**As-built Baseline Monitoring Report**  
**FINAL**  
**Greenbrier Stream Mitigation Project**  
**Yadkin County, North Carolina**  
**Monitoring Year 0**

NCDEQ Contract No. 7616  
DMS ID No. 100086  
USACE Action ID No. SAW-2018-01755  
NCDWR ID: 20181272

**RE: Response to Draft As-Built Baseline Monitoring Report (MY0) Comments dated July 24, 2020  
Greenbrier Stream Mitigation Site  
Yadkin River Basin – CU# 03040101 - Yadkin County, North Carolina  
NCDMS Project # 100086, Contract # 7616**

FIGURE 2

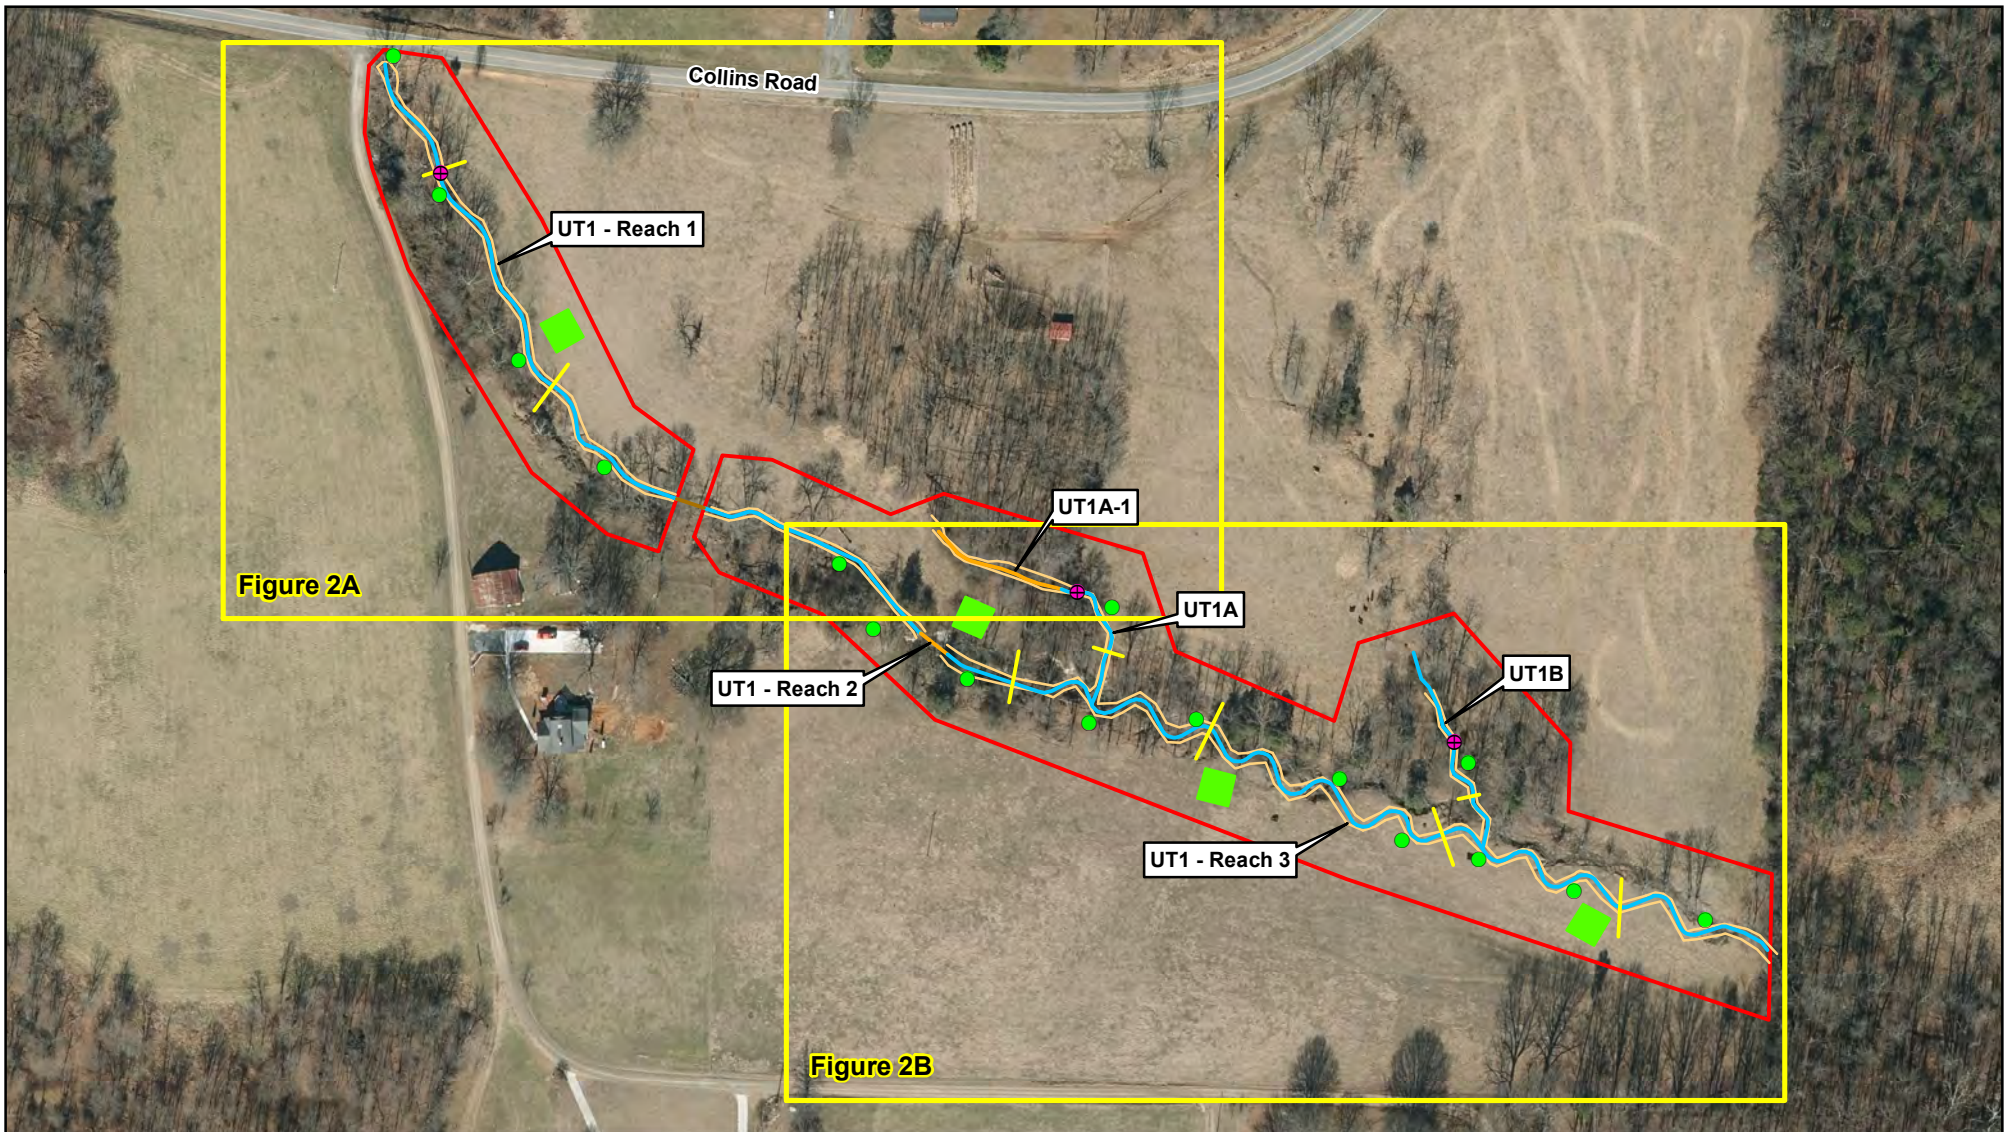
- **The project thermal regime information has been added to Table 4.**
- *CCPV Maps: Please remove the Pre-Existing Stream layer from the CCPV sheets in the report. Please keep this layer in the electronic support files for reference and documentation. DMS understands that this layer is requested in the MYO template/ guidance; however, it clutters the map for this project. DMS & EPR can provide the IRT with a comparison map of the existing channel and constructed channel upon request.*

- **The Pre-Existing stream layer has been removed from the CCPV map but the shapefile is still included in the electronic support files.**
- *Table 7: In the Annual Means column, the "size (ACRES)" cell is currently 0.10. With four permanent plots, shouldn't that be 0.08? Please QA/ QC and update the table as necessary.*

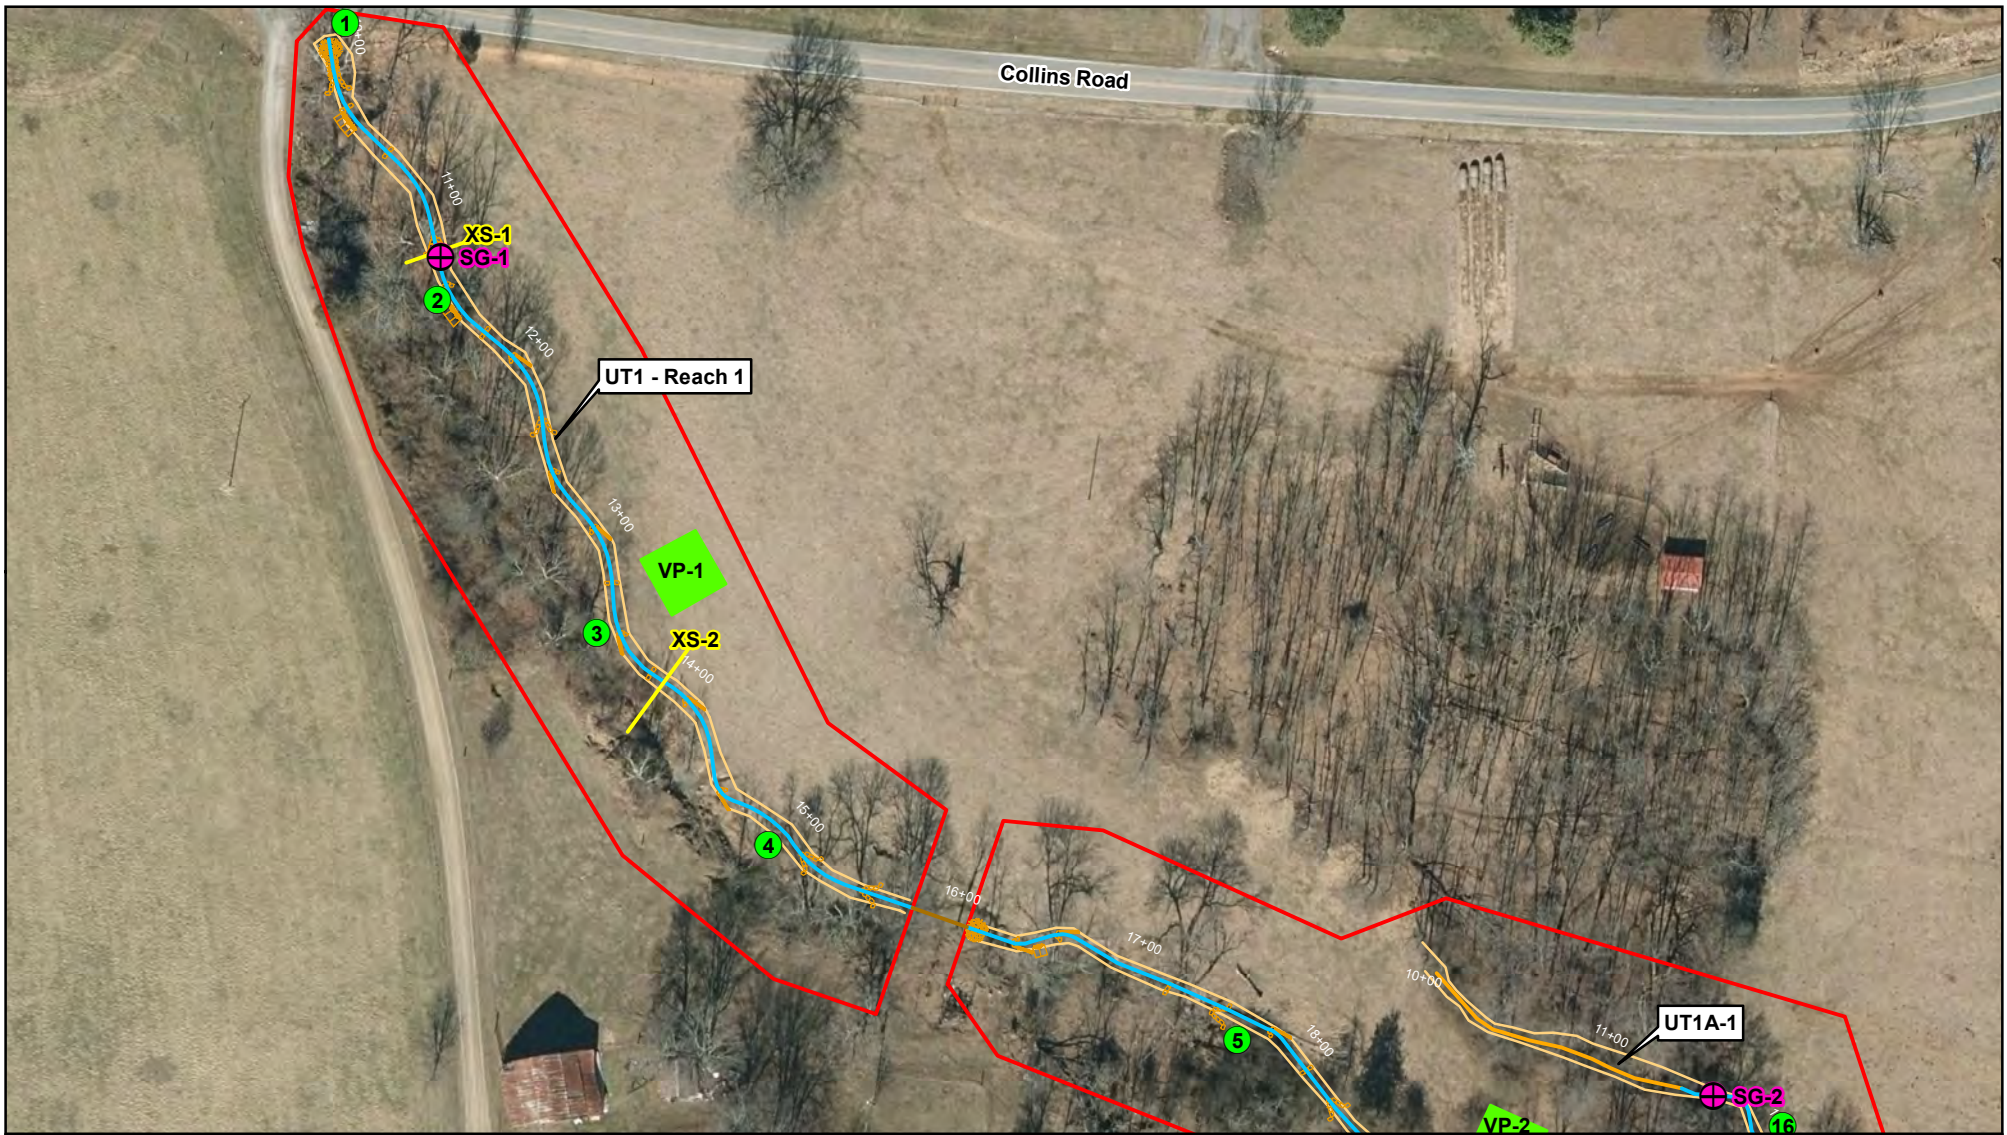
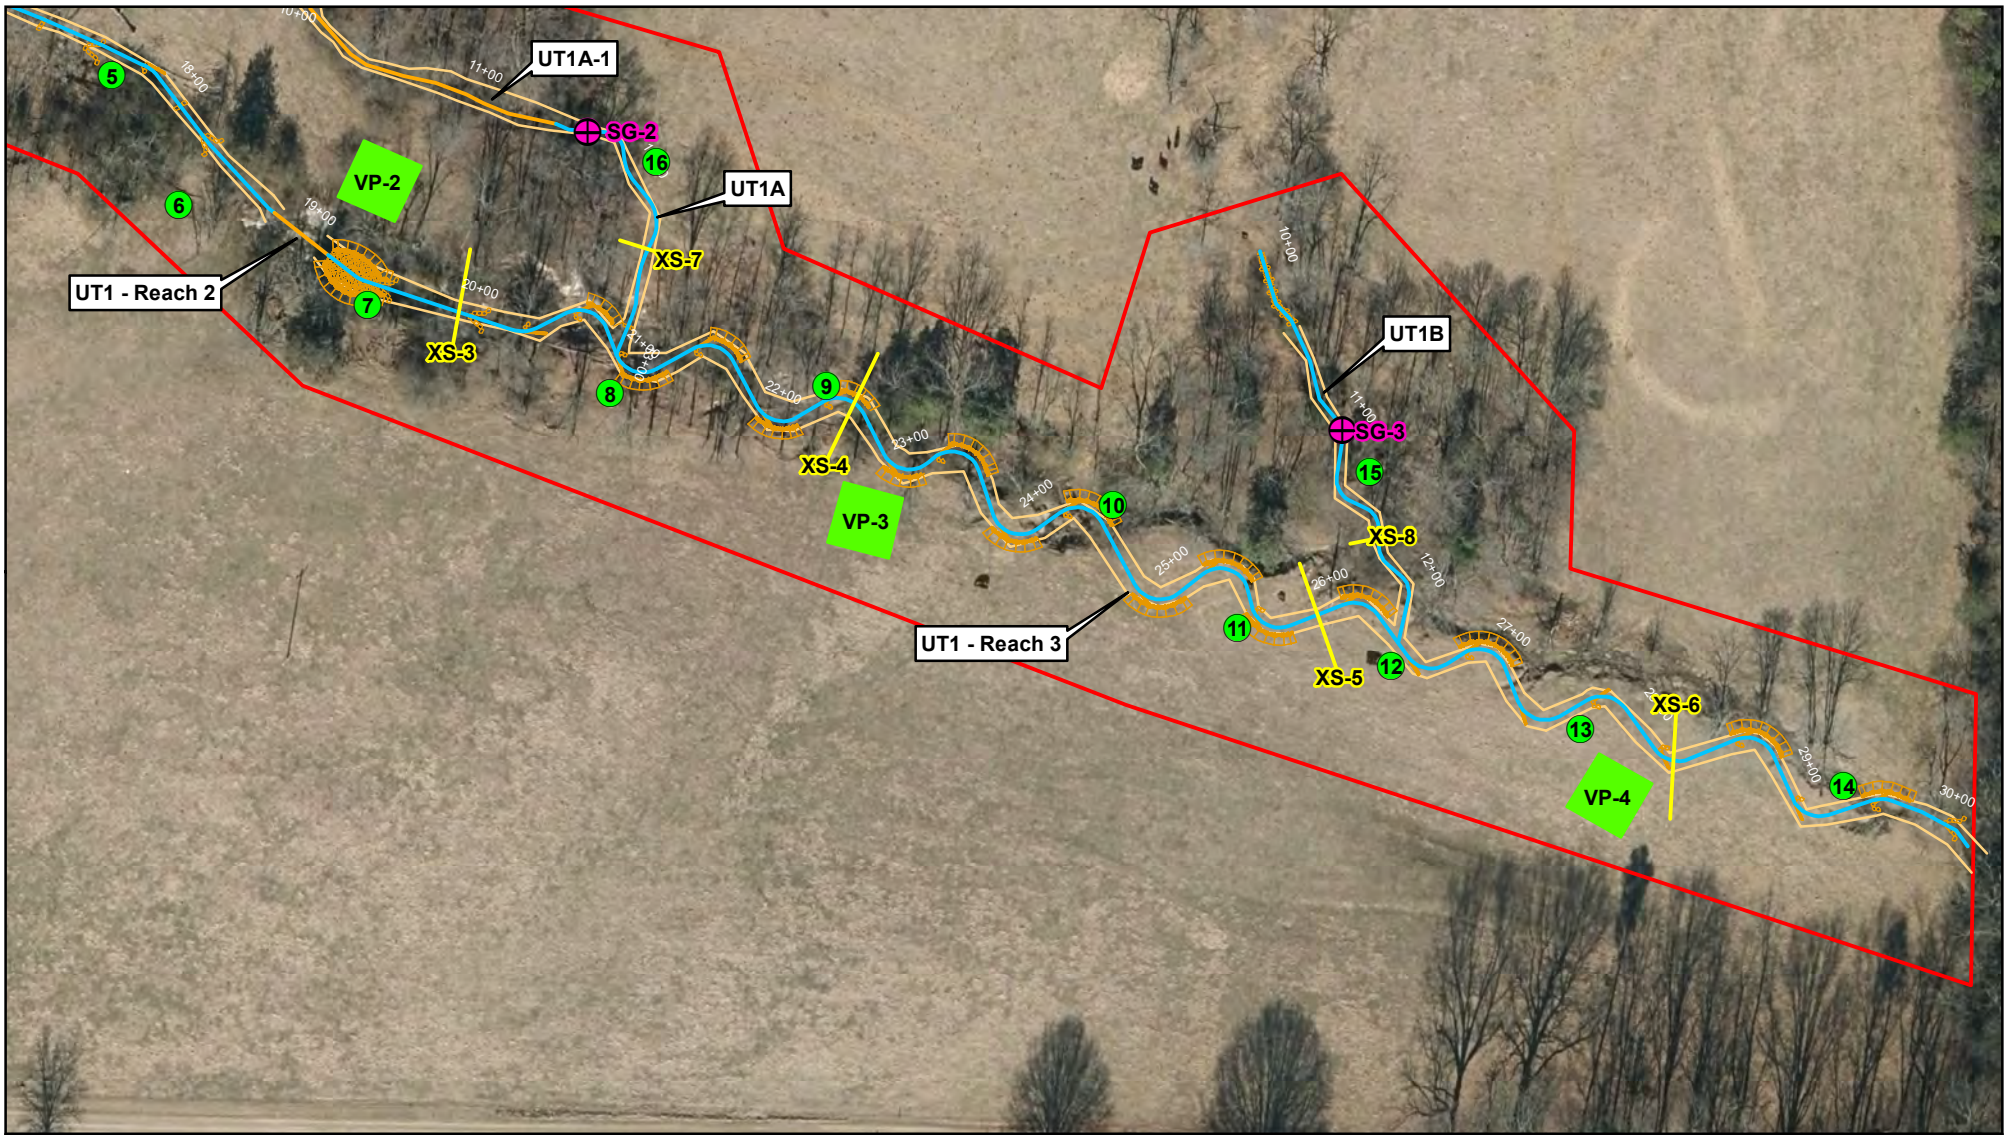
- *Please review and revise labeling in Figs. 2-2B, specifically for UT1R2 and UT1R3, as well as UT1A and UT1A-1.*
  - **Stream name labels in Figures 2-2B have been revised.**
